HISTORIC PRESERVATION BOARD STAFF REPORT				
	108 N. Swinton Avenue			
Meeting	File No.	Application Type		
June 5, 2024	2024-150	Certificate of Appropriateness		
REQUEST

The item before the Board is consideration of a Certificate of Appropriateness (2024-150) for exterior modifications to gable ends and trellis feature to the contributing single-family residence located at 108 N. Swinton Avenue, Old School Square Historic District.

THE PICUT RESIDENCE

SITE PLAN

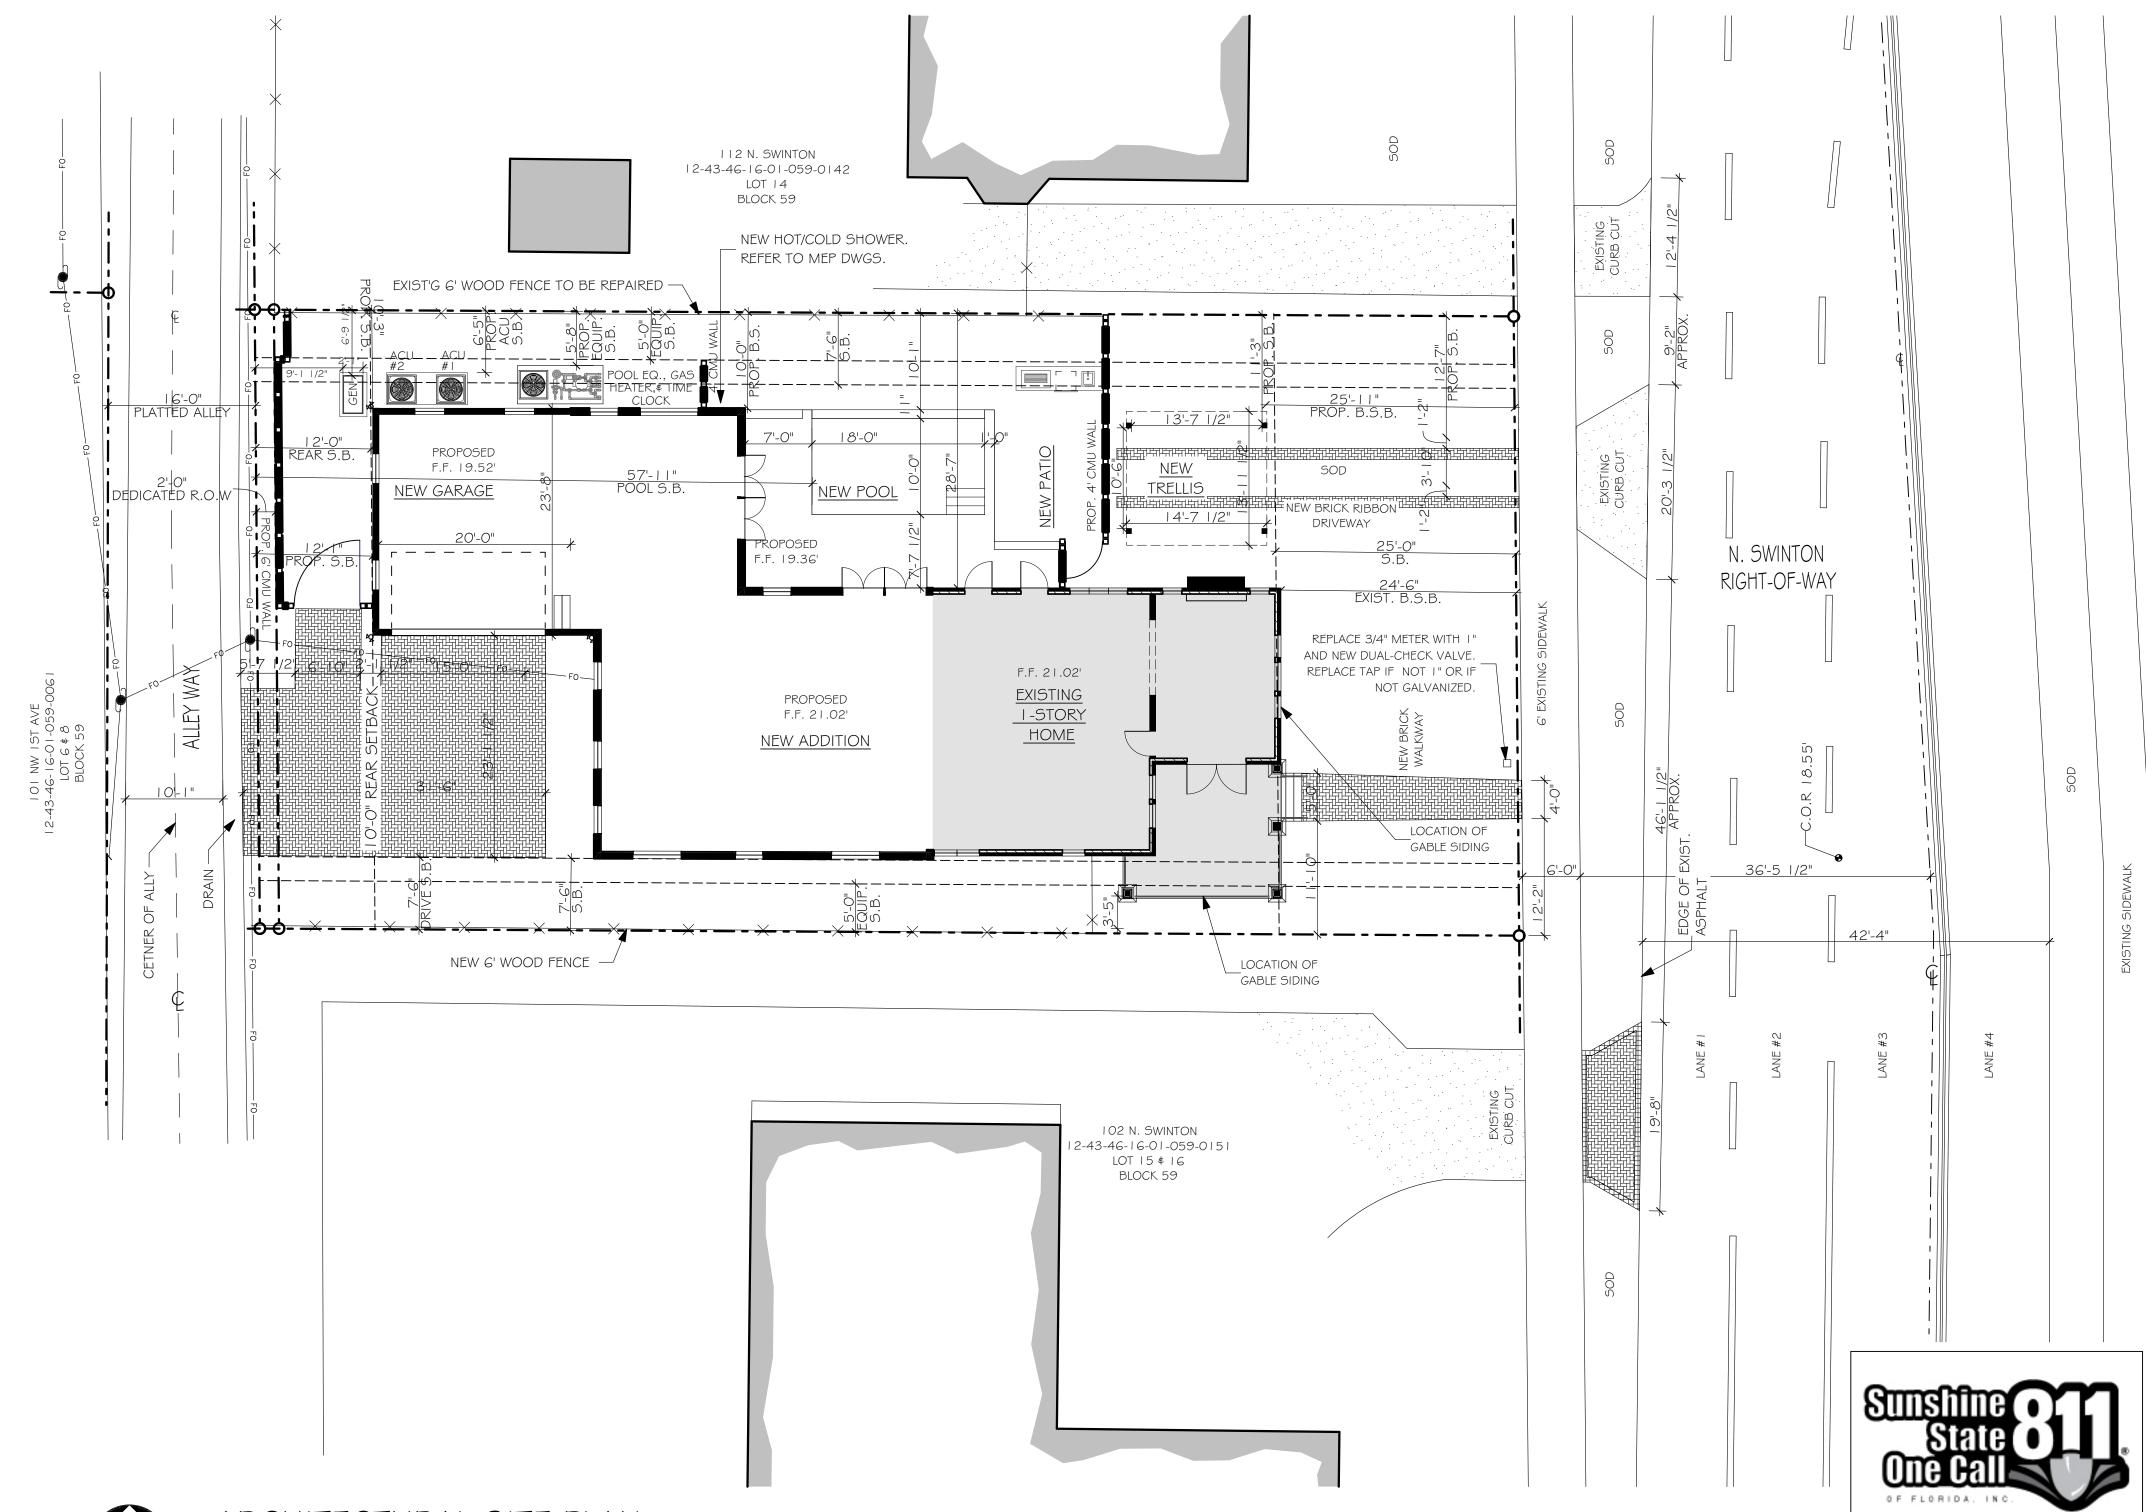
The proposal includes alterations to the approved trellis adjacent to the north side of the existing structure. The original approval included the use of wood posts that extended the full length down to the ground. The proposal includes the use of a stucco base.

The trellis structure is approved to cover one of the parking spaces in the front of the property, accessed from N. Swinton Avenue while the required parking for the home is located in the rear of the property accessed from the adjacent north/south alley. The location of the trellis is not proposed to change.

While the trellis will be slightly larger due to the wider stucco base, the alteration can be considered appropriate for the site, as overall the trellis is shorter than the front main structure, is setback from the

front façade, and retains the appearance of an accessory structure. There is concern however, that the proposed footers may create a similar appearance to the columns on the adjacent porch, along with making the trellis appear larger potentially competing with the front of the existing structure. The board will have to make a determination that the size, material, and color of the stucco support bases are appropriate and compatible with the Bungalow style residence. With regard to **Standards 9 and 10**, the proposed trellis modification is a detached, accessory, structure and the proposed materials are anticipated to be compatible with the materials used on the existing historic structure.

A2.1

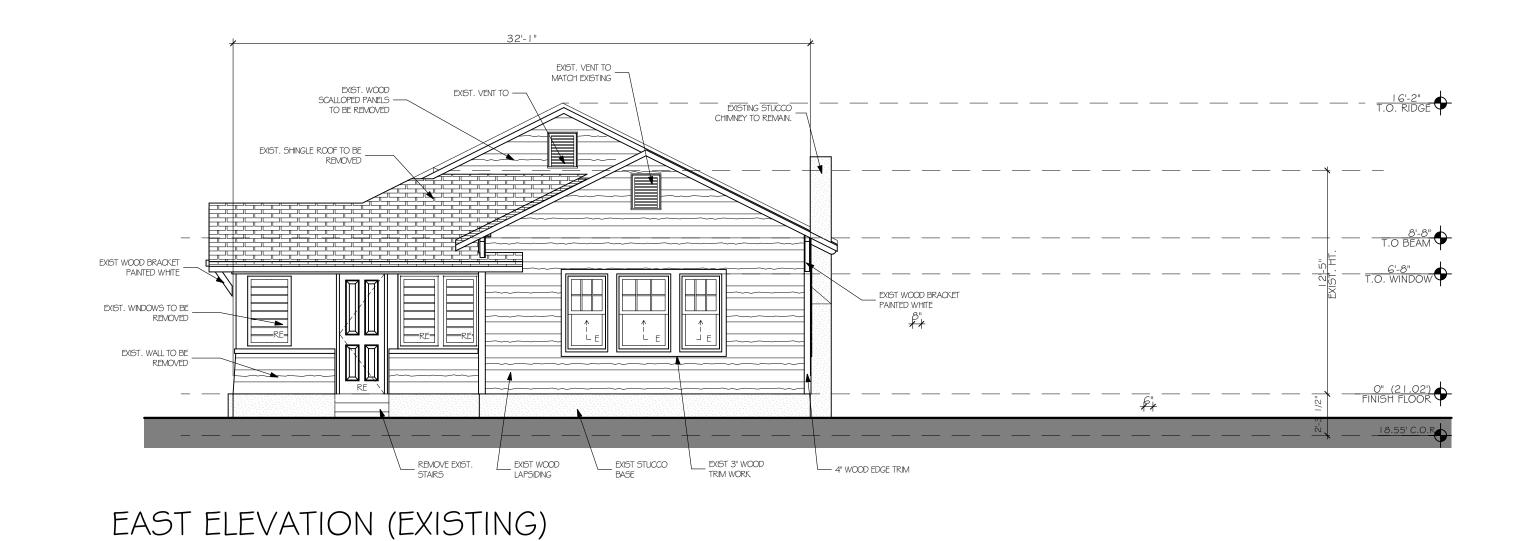
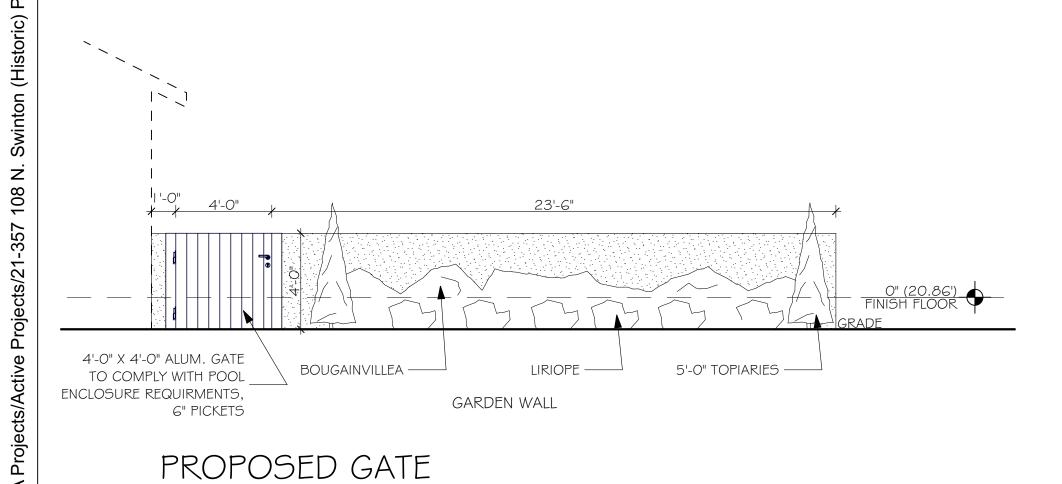
The subject request is for exterior modifications to the approved plans, including a change of material for the east (front) and south facing scalloped gables from wood to Hardie-board, and use of stucco bases for the trellis. The request is now before the board.

The subject request is for exterior modifications to the approved scalloped wood siding on the east (front) and south gable ends of the restored porch and addition of a stucco base to the trellis to a contributing one-story residence. The original design of the existing structure has been considered with respect to improvements.

Standard 1, 2, 5, 9 and 10 are applicable. The subject proposal consists of a material change from the scalloped wood siding to the east (front) and south gable ends of the restored porch to Hardie-board along with the addition of a stucco base on the approved trellis. With regards to **Standard 1**, , the existing structures' residential use will remain the same. Regarding Standards 2 and 5, the original structure had scalloped wood gable ends and the 2022 approved COA maintained the same wood material for the east and south gables. It is noted that the board approved the use of Hardi-board gable material in the rear of the property as such would not have a negative effect upon the historic façade and was associated with the new addition. Per the Secretary of the Interior's Guidelines the use of composite materials is not typically considered an appropriate approach when replacing original wood elements. Therefore, the board will need to make a determination that the proposed Hardi-board material is appropriate for use in this instance.

Regarding the scalloped Hardie-board siding around the east and south facades of the home, there is concern with the use of composite materials on the historic structure. It is noted that the board approved the use of Hardi-board gable material in the rear of the property as such was associated with the new addition eliminating any negative effect upon the historic structure. The applicant has indicated there is difficulty meeting wind load calculations and insurance requirements with the custom wood siding. Consideration could be given to the amount of scalloped siding proposed and the particular elevations affected, such as the front versus the side interior.

The proposed change will revise the wood scalloped siding to cements siding as similar wood siding to the rear was not available. Custom siding will not meet wind and insurance requirements, also it is extremely costly. Color will not change and will remain as approved. All other items, other than the scalloped gable siding is wood and will not change.
